RE: Revalidation of LOMR-11-10-033P

Technical Memorandum
Revalidation of Coastal Flooding Analysis and Mapping for Burien LOMR 11-10-0033P

Figure 1. Correlation of southerly winds, Point Robinson and SeaTac, 2010 – 2012

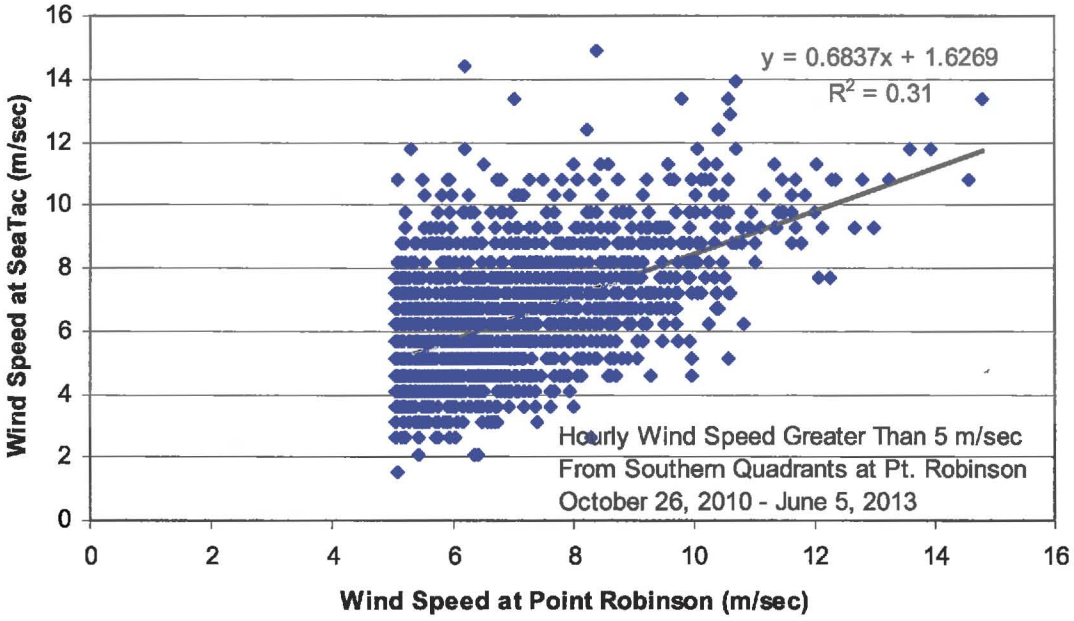
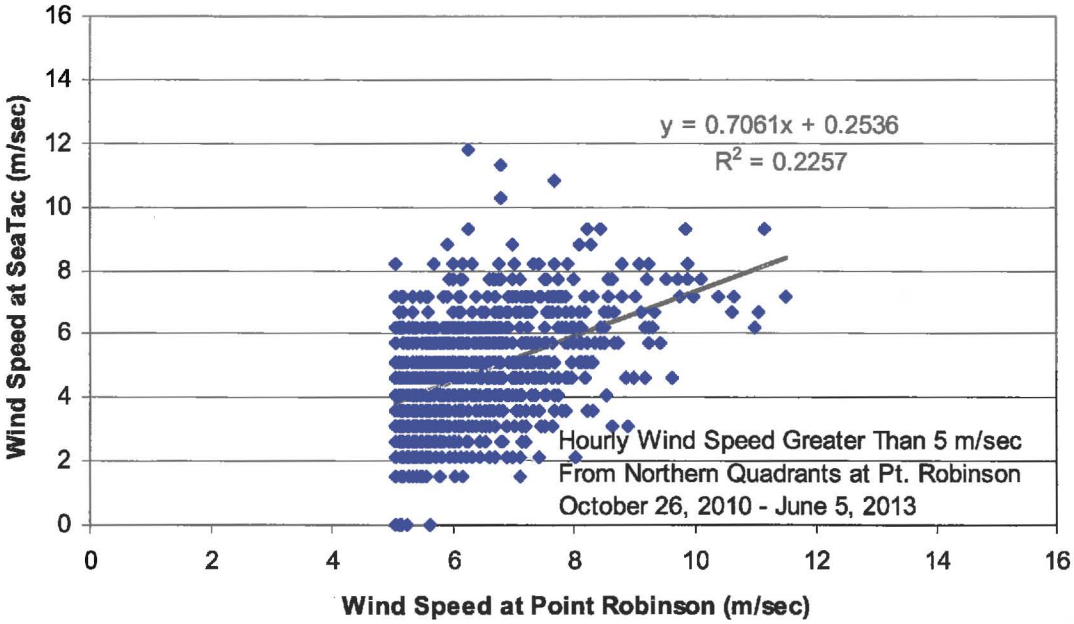
NHC generated a 62-year long record of wind speed and direction in the King County study for a statistical base to develop input to the SWAN model by extending the records of anemometers near Puget Sound through correlation with SeaTac Airport wind data. The accuracy of the extended wind record is reduced if the correlation of speeds between the short- and long-term stations is poor. As one example, Figure 1 is a plot of wind speed values greater than 5 meters/sec from the south for Point Robinson matched in time with wind speed measured at SeaTac. Point Robinson is on the eastern tip of Maury Island and is nearer to SeaTac than the other stations NHC analyzed. Figure 2 similarly plots wind speed values from the north. The low R-squared values shown in Figures 1 and 2 (0.31 and 0.23, respectively), reveal that the fraction of the variance explained by the linear regression is very low. (R-squared value of 1.0 implies perfect correlation between two linearly related variables.) The correlation between SeaTac and Point Robinson is poor and is different for north winds and south winds. Relying on regression with SeaTac for wave generation in Puget Sound adds a large uncertainty to the results. Attempting to correlate speeds without consideration of north or south directions also adds uncertainty to the wave runup results, particularly at shorelines exposed to the north.

Figure 5. Pass point elevations for wave input to runup calculation in King County study

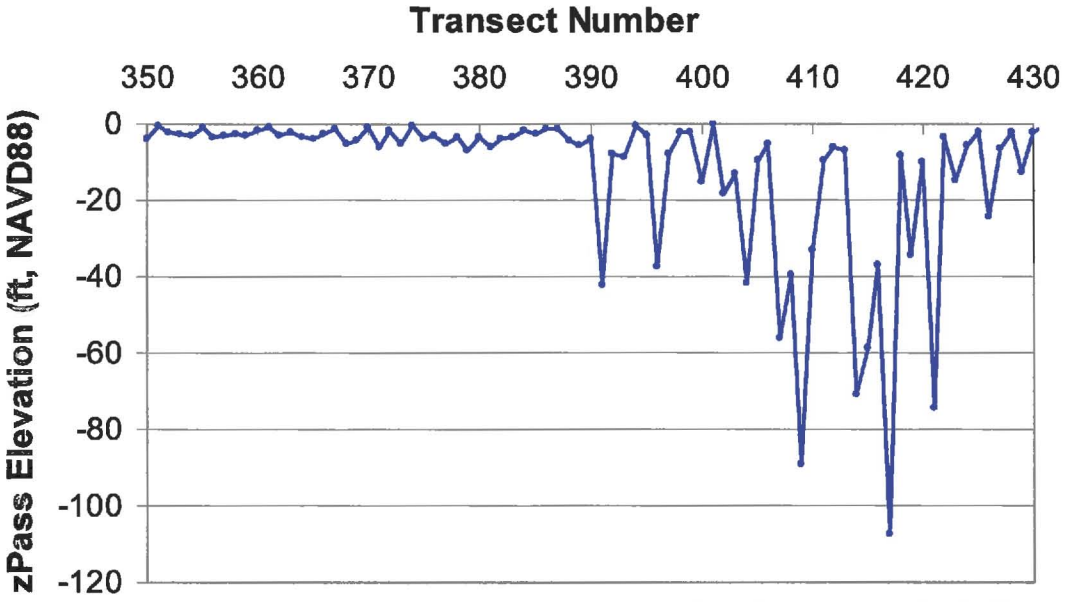
NHC generated files that contain information on elevation of the pass point for the analysis transect. This is the location where modeled wave height, period, and direction output were transferred from the SWAN model to other routines that compute wave runup and overtopping at the shore. Values listed under the column heading "zPass" in the NHC file named RunupOutputKey.XLSX show that the bottom elevation at which wave height and direction were passed to the runup routine varied from -0.2 ft to -107 ft (Figure 5). Half of the zPass values for Burien transects were less than -3.8 ft. Extracting SWAN model results so close to shore could cause the wave height input to the routine for runup without structures to be too low (wave already broken), depending on tide level. Where the pass point is selected at a point too far from shore, refraction effects on wave height and direction are not fully accounted for and an inaccurate factor is calculated for wave direction effect on runup on a structure. The pass point should be located seaward of the breaking zone in all cases, but in water shallow enough to reasonably represent refraction effects.

In the Burien LOMR study, SWAN wave information computed at a nearshore location with bottom elevation of -3 meters (-9.8 ft) was passed to runup routines for all transects. CHE analyzed wave transformation for determining optimal depth for specifying the pass point location. Wave height for an example high tide case for a west-facing part of the shore was selected for comparing calculated wave height at different water depths approaching shore. The significant wave height was 1.01 meters at the minus 3-meter bathymetric contour, and 1.08 meters at the minus 25-meter (-82 ft) contour along the same transect, only 7 cm different for a large storm wave (for central Puget Sound). Water depth at the minus 25-meter contour is considered deep water for wave periods at this location. The wave direction, however, was 10 degrees different between those two water depths. Direction at the -3-meter contour better represents the approach direction of the wave to the shoreline. The pass point should have a constant elevation for consistency of results. Considering

height and direction together, SWAN model results of waves transformed to the -3-meter contour are optimal for use in wave runup statistics for beach profiles and at structures.

Figure 6. Runup height at Burien shoreline calculated by NHC and CHE

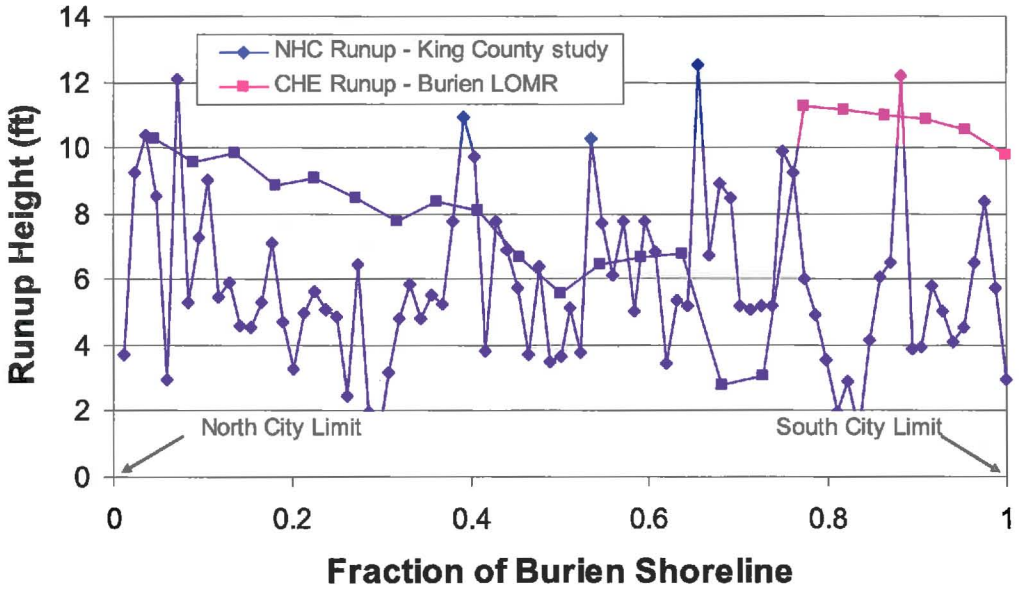
Wave runup heights above static water level for the case of the one-percent-chance flood at the Burien transects ranged from 1.38 ft to 12.51 ft in the NHC analysis. The CHE runup calculation ranged from 2.8 ft to 11.3 ft. Values calculated by CHE are in a narrower range than those of NHC. Figure 6 compares the runup heights calculated in the two analyses for transects arranged from north to south in the Burien city limits. The figure illustrates the erratic runup values calculated by NHC, and indicates the uncertainty factors described above are likely responsible for the large changes in runup at successive transects. NHC

(2011, p. 27) states that engineering judgment was used to deal with the irregularities by averaging values and ignoring isolated anomalies to determine average characteristics along a shoreline. STARR's recommendation to supersede the Burien LOMR with the King County study on the basis that procedures NHC employed are more robust is negated by the practice of averaging through irregularities and using engineering judgment to derive mapping parameters. CHE made no arbitrary adjustment of runup elevation in the analysis for the Burien LOMR.

Figure 8. Portion of draft work map by NHC showing large landward extent of AE Zone

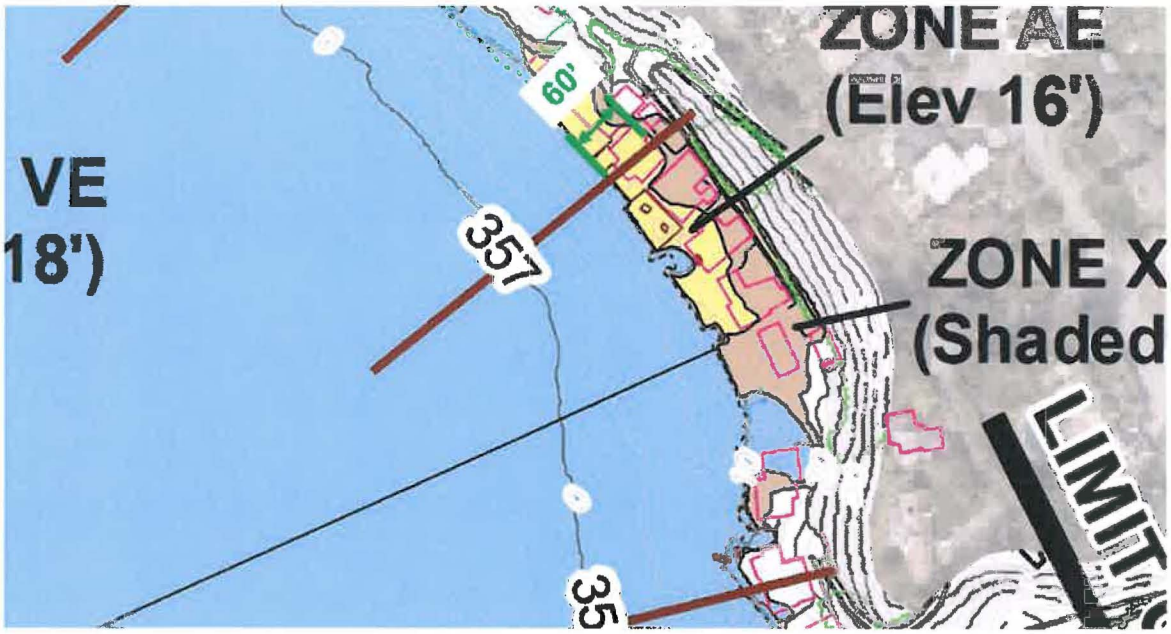
NHC mapped AE Zones and no AO Zones at Burien in the King County study. The AE Zone limit corresponded to the location of topography with elevation equal to the AE elevation because energy dissipation with overland travel was not accounted for. CHE's analysis did account for dissipation of the overtopping wave, and was therefore able to delineate the AO Zone at a location having a ground elevation lower than that of the initial overland bore. AE Zone is described in FEMA (2005) as area with wave height less than 3 ft. AO Zone is described in Section D.4.9.2.4. as "sheet flow … dissipating because of ground friction and energy losses." For cases where waves overtop a bulkhead and dissipate on a level lawn, as at most of the Burien waterfront properties, the more appropriate description is Zone AO. One example of NHC mapping according to topography, with the result indicating the A Zone extended over 60 feet landward from the bulkhead, is at King County transect 357 (Shorewood Lane), shown in Figure 8.

Figure 10. Comparison of hazard zone limits of Burien LOMR and King County Mapping at Shorewood Lane

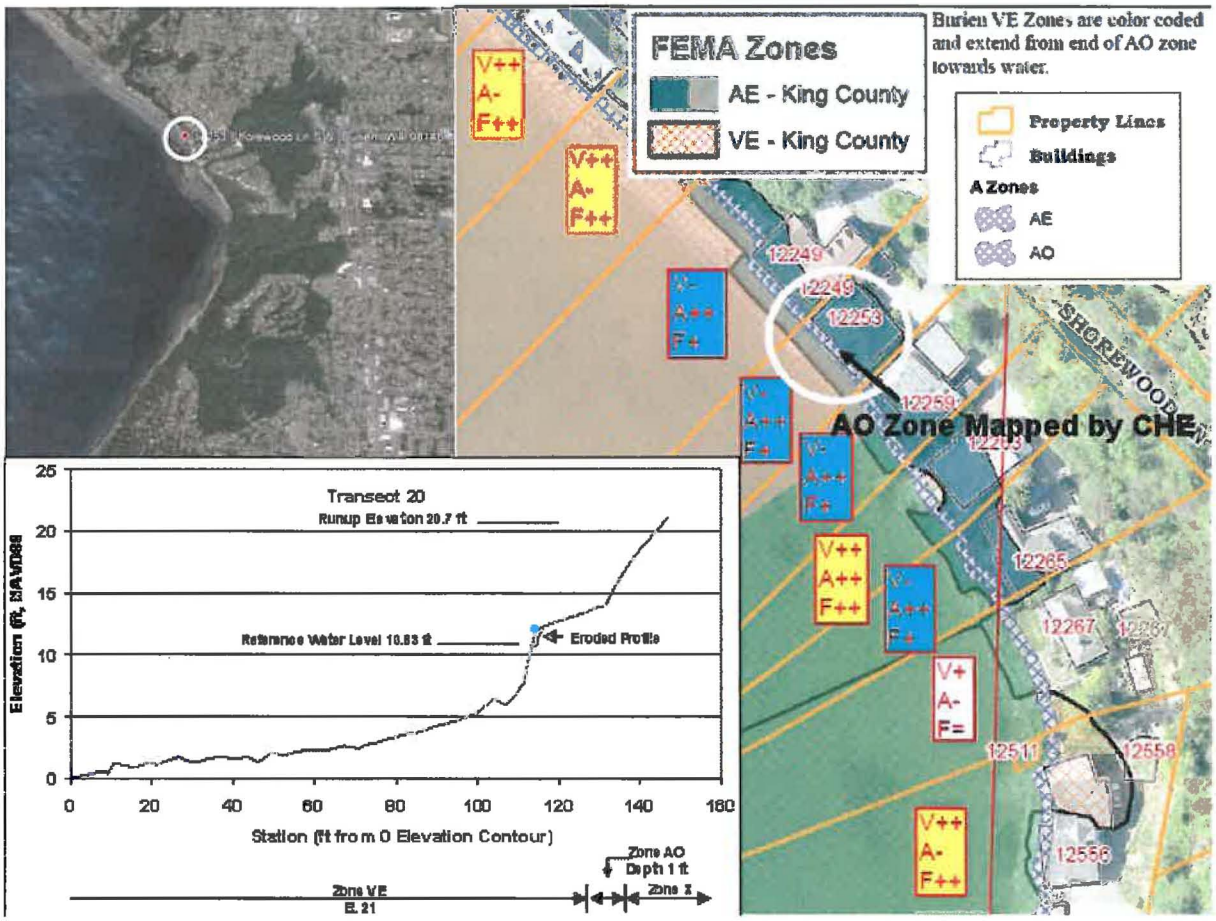
The shoreline reach containing King County transect 357 is represented by CHE transect 20. A ground photograph characterizing the shoreline in this reach is shown in Figure 9. Most structures are set back from a nearly vertical bulkhead. Analysis and mapping results of runup and overtopping for the Burien LOMR are shown in Figure 10. CHE calculated the AO Zone limit to be 22.8 ft landward from the bulkhead in Reach 20, and the LOMR mapping of hazard zone limits are compared with those of NHC in the figure. Text by the circled residential lot (King County transect 357) indicates that the King County mapping reduces the width of the V Zone and greatly expands the width of the A Zone relative to the effective map. Although experience at the site is anecdotal, appearance of storm effects and history of the site indicate CHE's results are more realistic for this shoreline reach. Investment in improving these properties has been gradual over many decades, and in most cases structures have been placed landward of the extent of storm damage based on experience.

Figure 12. Comparison of hazard zone limits of Burien LOMR and King County Mapping at S.W. 172nd Street and validation of CHE calculation results

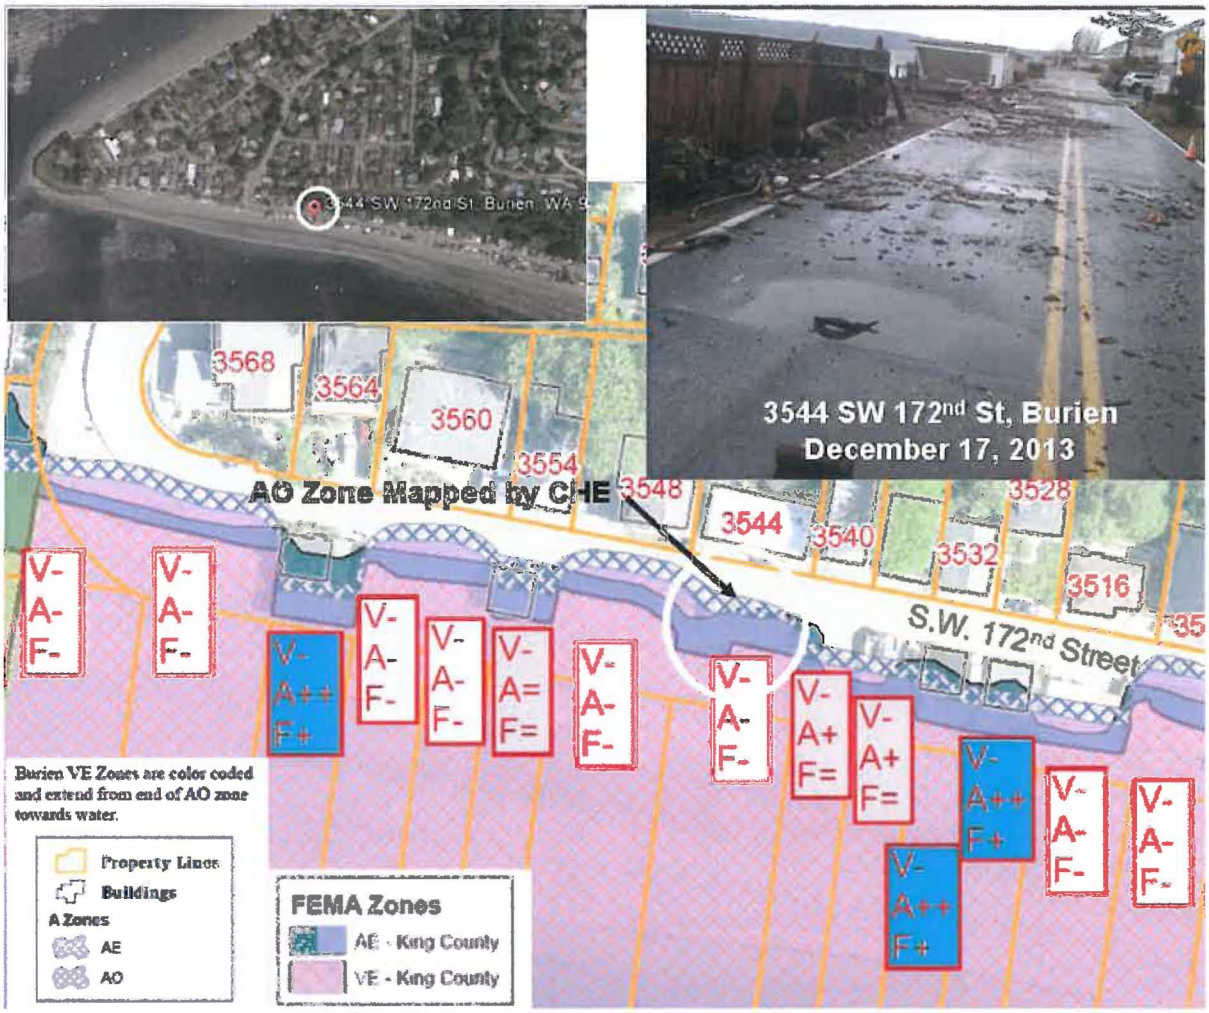
Although King County mapping by NHC increases the flood hazard designation for 160 Burien properties as compared to the effective map established by the LOMR, some other properties are shown to have a decreased flooding risk. The area of S.W. 172 Street on the south-facing side of Three Tree Point is shown in Figures 11 and 12 on December 17, 2012. The high water event at Burien on that date is historic. High tide at the Seattle NOAA tide gauge on that date was the highest ever recorded there[1]. In the hours preceding the peak of the tide, wind speed measured at Point Robinson was 20 to 30 miles per hour from the southerly direction, which would produce high waves. Figure 11 shows the water level at the bulkhead and the large-size debris tossed onto the upland within the short distance from the bulkhead, which tends to validate CHE's calculation of VE Zone width there. Figure 12 compares the hazard zone limits calculated by CHE and by NHC for the area of S.W. 172nd Street. In the figure the V Zone limit mapped by NHC is located at the bulkhead and the AE Zone extends only a few feet landward. CHE calculated the V Zone to extend landward of the bulkhead face and the AO Zone to extend into S.W. 172nd Street. Small-size storm debris on the street marks the extent of wave overwash and is an indicator of the A Zone limit. The comparison in Figure 12 illustrates the accuracy of CHE's mapping of the AO Zone limit and the under estimation by NHC of overtopping distance at properties in this reach.
